**INDEX**  
**NMED's Concern**  
**EPWU AE Exemption**

RE: New Mexico Environment Department Comments on Aquifer Exemption Request  
for Class V Injection Wells (Authorization No. 5X2700062)

Re: EPWU Application for Aquifer Exemption  
Class V Authorization 5X2700062, Tracking No. 12421324-1  
CN602957060/RN104809389  
Kay Bailey Hutchison Desalination Plant

**EPWU Application for Aquifer Exemption  
Response to TCEQ Comments of June 21, 2010**

Figure 1. Location map showing the study area relative to the eastern portion of El Paso County. This illustration also provides the location of the 4 exploratory test wells and three alternative sites being considered for the desalination plant to be built in 2005-06.

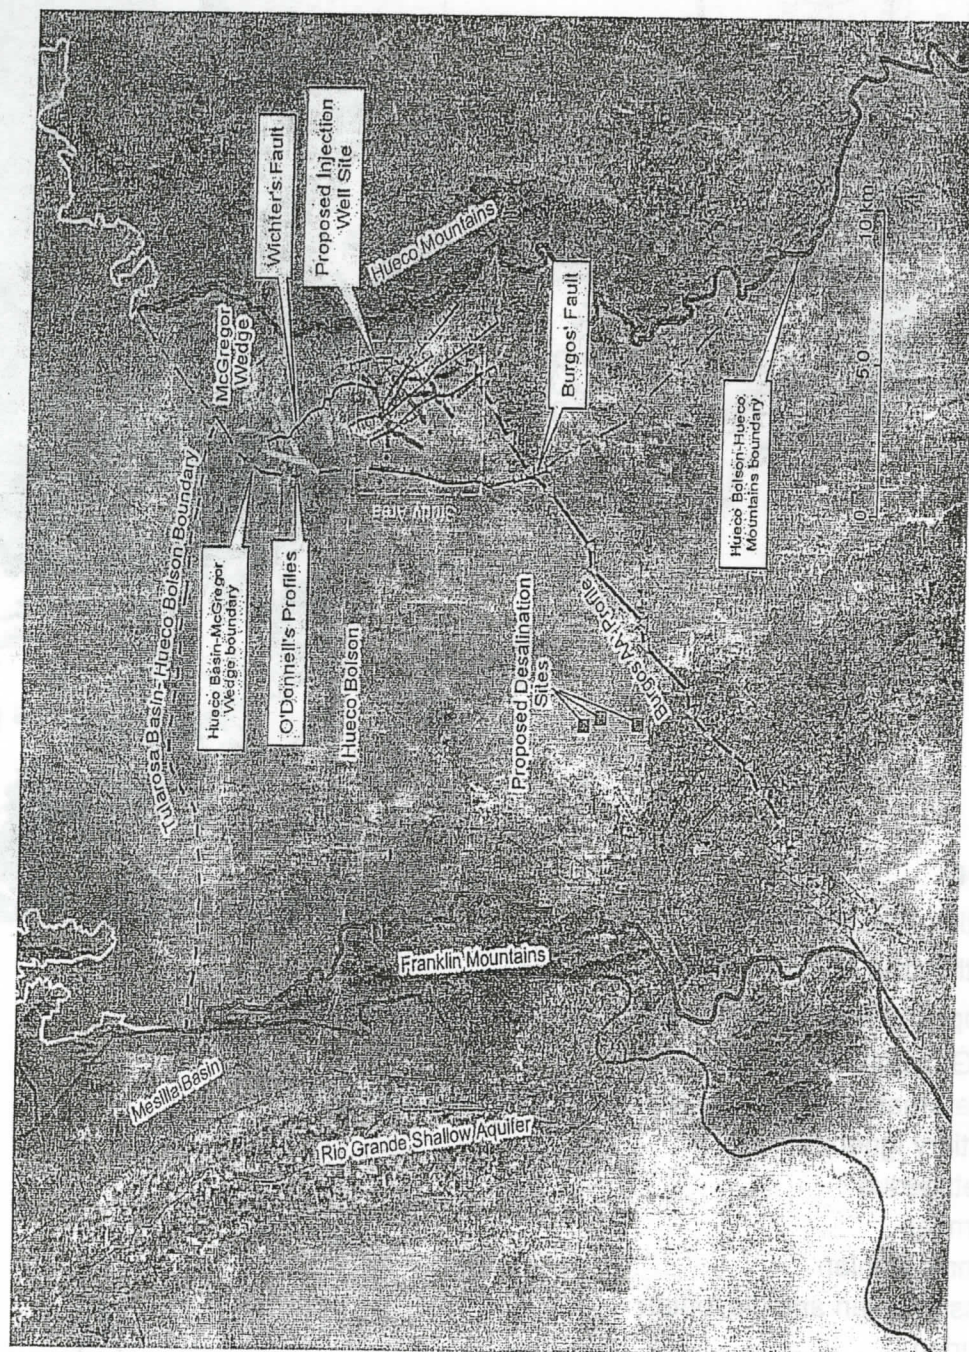
Based on work done by Granillo<sup>1</sup>, the existing Class V injection wells are in the McGregor Basin, which is a graben of about 2200 acres that lies within the McGregor Shelf Figure 1 and Figure 37 from Granillo). This shelf is a structural block that lies between the Hueco Bolson on the west and the Diablo Plateau on the east. Granillo's work indicates that geologic units within the McGregor Basin are structurally separated from the same units on the Diablo Plateau. This is true for the Silurian Fusselman Formation, which is the injection zone for the Class V injection wells being operated in the McGregor Basin. Granillo describes the McGregor Basin as a closed feature that geometrically resembles a bath tub, whose sides primarily consist of Paleozoic and Mesoproterozoic bedrock. Based on the geophysical results of the McGregor Basin and 30 year water injection simulation studies, Granillo's preliminary conclusion was that the McGregor Basin is a suitable natural reservoir for a deep injection well<sup>2</sup>. Information provided by Granillo indicates that fluids injected into sedimentary units within the McGregor Basin will stay within the basin.

FIGURE 5

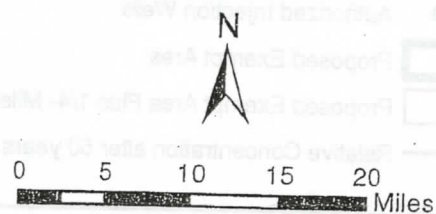
As illustrated on the geologic map in Figure 5 of the report, Ordovician and Silurian rocks crop out about 15 miles southeast of the injection wells, along the southeastern boundary of the Diablo Plateau. According to information on the Van Horn-El Paso Sheet of the Geologic Atlas of Texas<sup>5</sup>, these rocks represent the Ordovician Bliss Sandstone, the El Paso Formation, the Montoya Dolomite, and the Fusselman Dolomite. On page 17 of the report, these formations are identified as those of the proposed exempt aquifer. Therefore, rocks of the proposed exempt aquifer actually crop out southeast of the injection wells. Topographic information on this map indicates the base of the Bliss Sandstone crops out at an elevation of about 4100 feet.

Figure 11 of the report is a map of the assumed steady-state potentiometric surface for groundwater in the proposed exempted aquifer area. A comparison of this potentiometric surface to the geology illustrated in Figure 5 indicates that the assumed potentiometric surface for the groundwater in the proposed exempted aquifer area is at an elevation of 3250 to 3450 feet in the area where Ordovician and Silurian rocks crop out. In that the base of these rocks occurs at an elevation of about 4100 feet in this area, the assumed potentiometric surface associated with groundwater in these units is 650 to 850 feet below the base of these units. Clearly, at least in this area, the elevation of the assumed potentiometric surface associated with groundwater in the proposed exempt aquifer is incorrect. Therefore, the results of any groundwater modeling based on this assumed potentiometric surface are questionable.

FIGURE 11

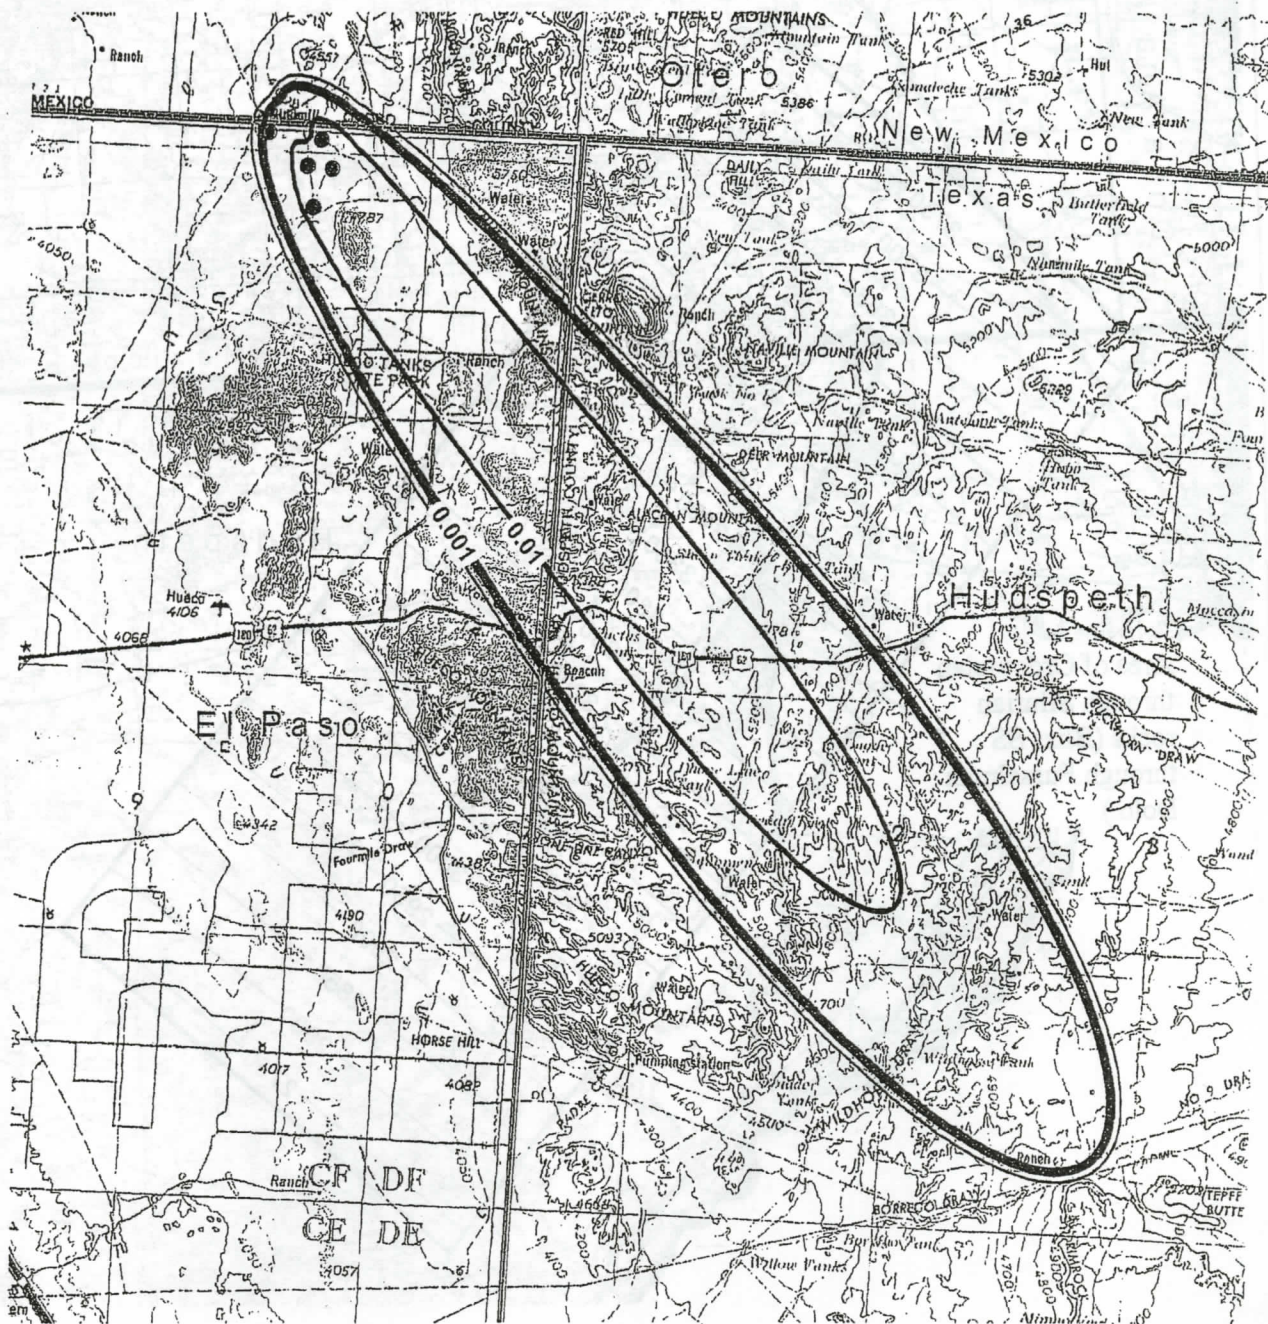
Additionally, it is unclear as to why the magnitude of the hydrologic gradient between wells JDF-1 and JDF-3 (0.007 ft./ft) was used to characterize the hydrologic gradient over the area that was modeled (Figure 11 of the report). This gradient, which was measured between two wells that are about 3300 feet apart, was extrapolated to represent the hydrologic gradient over an area 28 miles by 66 miles, and then only after the direction of the gradient was rotated almost 85 degrees. No justification was given for this extrapolation or rotation.

**Exhibit 6 – Steady-state potentiometric contours**

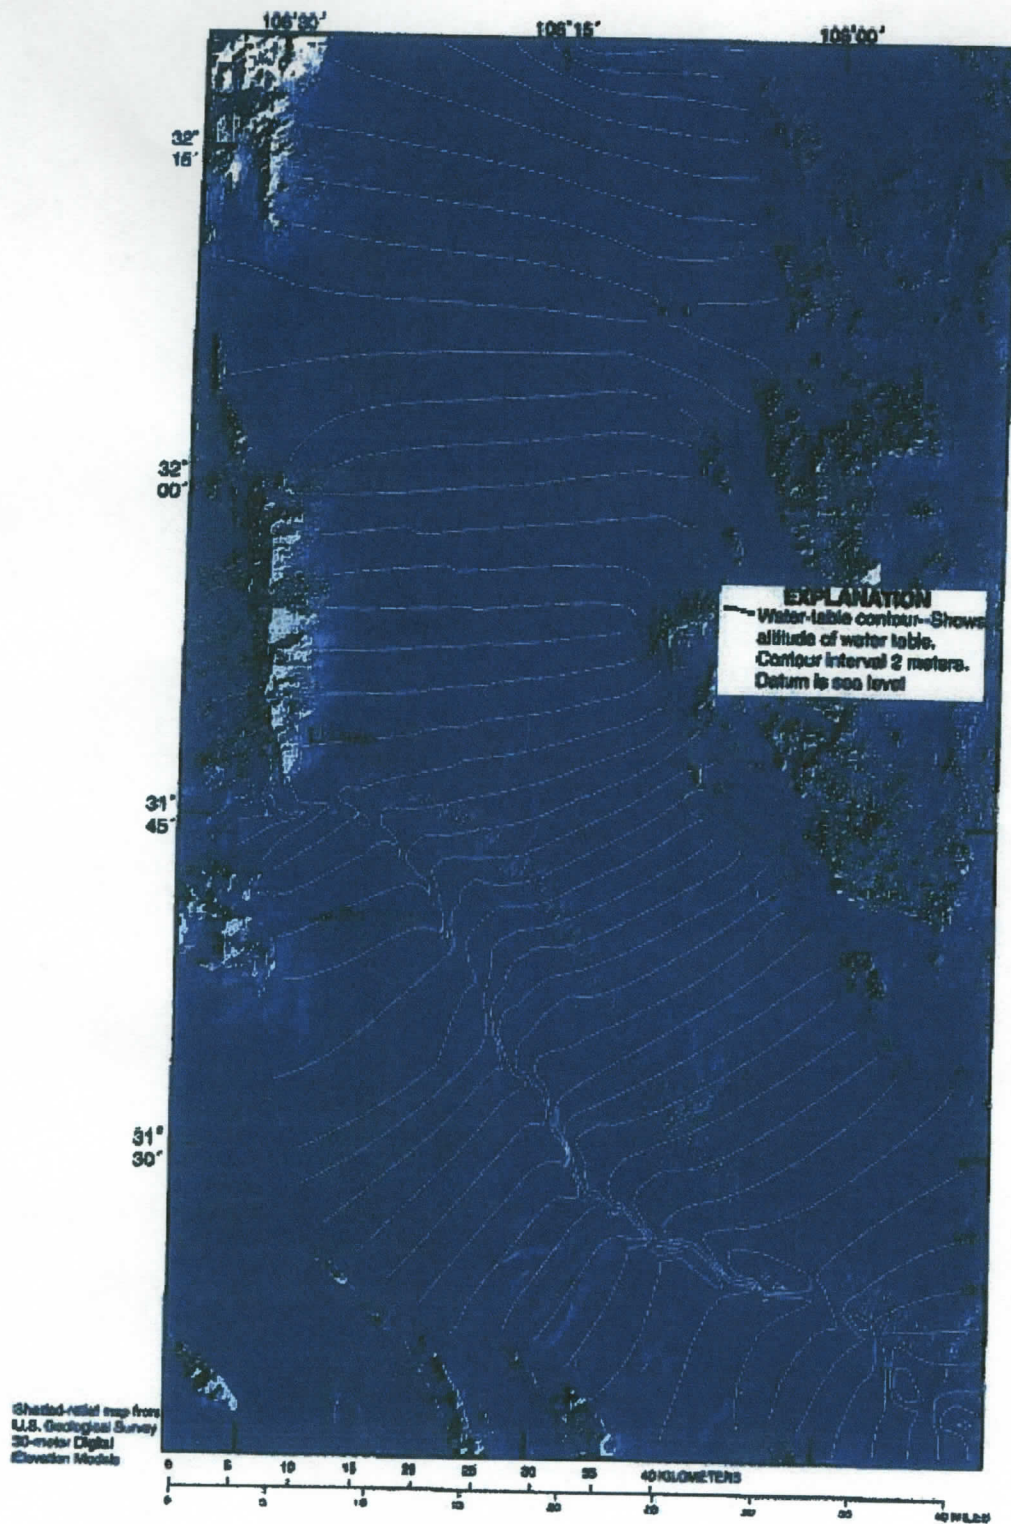
**TCEQ Comment:** Under the heading titled "Conceptual Model" (pgs. 21 – 23), EPWU states that the assumed groundwater gradient in the injection zone was 0.003 ft/ft, based in part on the groundwater gradient in the Hueco-Tularosa Aquifer, as reported in an EPA document. The TCEQ is unsure as to how this gradient was determined. It is the TCEQ's understanding that except for water level data from the three injection wells at the site, EPWU has no other groundwater level data for the area that was modeled. Given the size of the area modeled, the TCEQ is not convinced the groundwater gradient in the modeled area is valid. Please provide additional information to support the assumed gradient for the modeled area.

**EPWU Response:** The hydraulic gradient was determined by measuring head difference over a given distance based on potentiometric maps developed from regional water level measurements. In this case, the maps were from the EPA publication "Transboundary Aquifers of the El Paso/Ciudad Juarez/Las Cruces Region" (1997). The estimated hydraulic gradient is conservative and still indicative of the regional flow in the shallower Hueco-Tularosa system. Based on findings from other regional systems, we feel it is appropriate to use the regional gradient and general flow direction for the deeper units such as the injection zone.

# TCEQ Comment #1

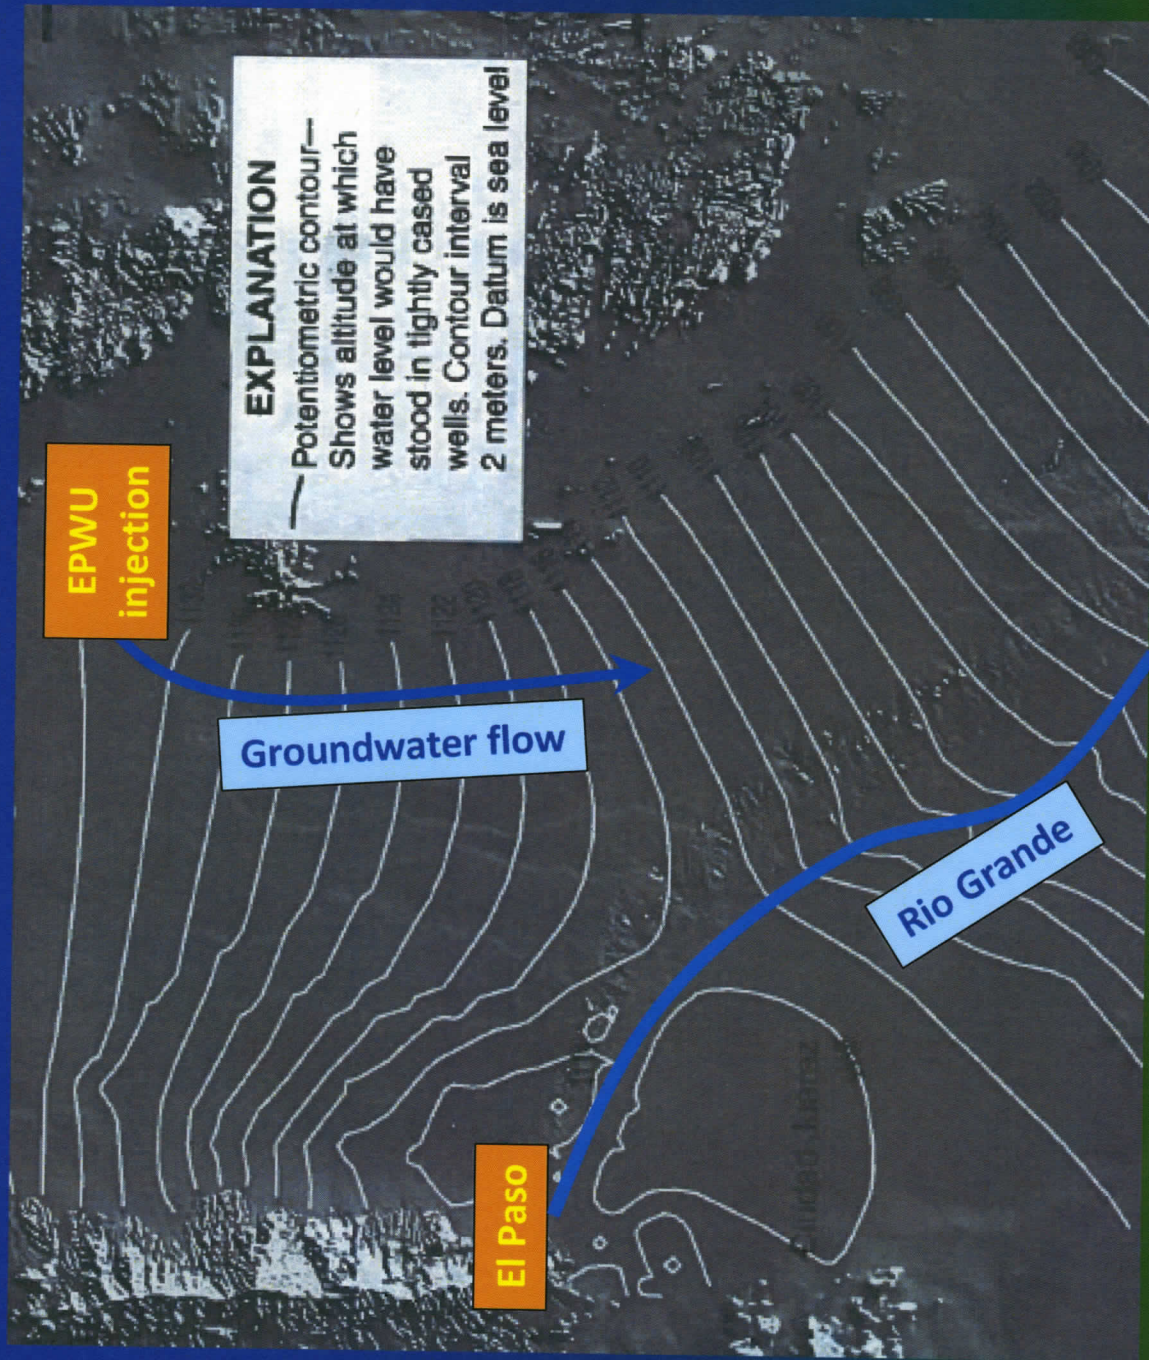
- LBG states that static water level data supports a south to southwesterly flow and groundwater movement to the south can be interpreted by the temperature gradient studies. In the 2008 application, LBG states that static water level data supports a south to southeasterly flow and groundwater movement to the south and southeast can be interpreted by the temperature gradient studies. Please provide the justification for this change in direction.

- The statement was meant to indicate that the flow direction throughout the region is generally to the south, as opposed to the north.
- The following USGS map also indicates that the regional flow direction, based on measured water level data, is also to the south.

# TCEQ Comment #2

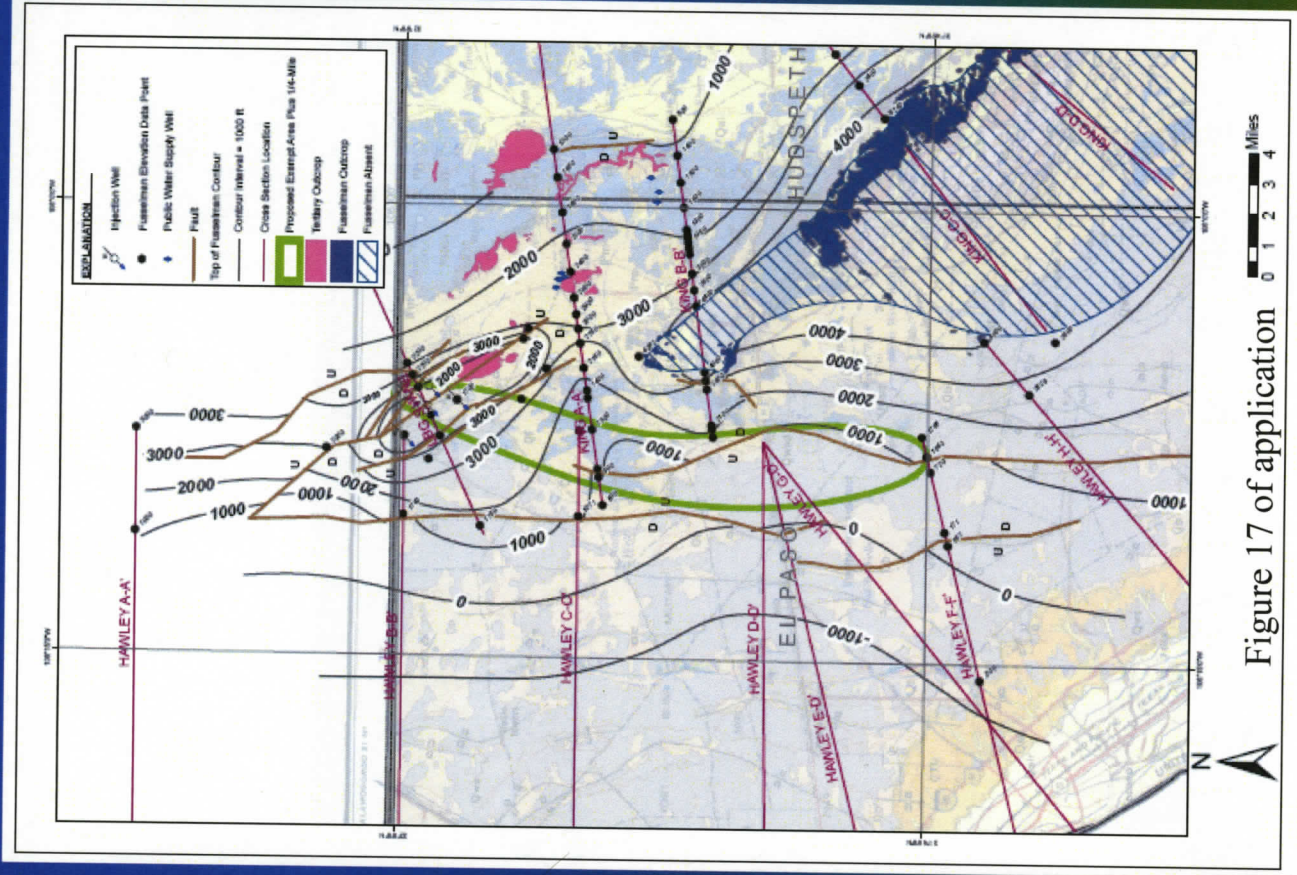
- EPWU states that a groundwater flow direction of south was assumed for groundwater flow in the injection zone. This assumption was based on a similar flow direction for groundwater in sediments of the overlying Hueco-Tularosa Aquifer, as described in an EPA document. The TCEQ is unsure of the validity of this assumption for two reasons. First, the injection zone dips west, as is illustrated on Figure 17. Second, units of the injection zone crop out to the east in the Hueco Mountains (Figure 5), providing an area of recharge for the injection interval. These two features would favor a westward direction for groundwater flow. Please provide additional information to support a southward groundwater flow direction in the units of the injection zone.

- We agree that the injection zone dips to the west, and that geologic structure may play a role in the flow direction, but is not the final determinant of groundwater flow. Groundwater flows from higher "total potential" to lower "total potential". (Freeze and Cherry, Groundwater, page 20)
- While there is Fusselman at the surface to the east of the injection zone, detailed hydrogeologic evaluation indicates that the Fusselman is not present west of that surface outcrop. In addition, scientific publications document that the regional groundwater flow in that area is to the east toward the Diablo Plateau. (Kreitler, Mullican and Nativ, 1990)
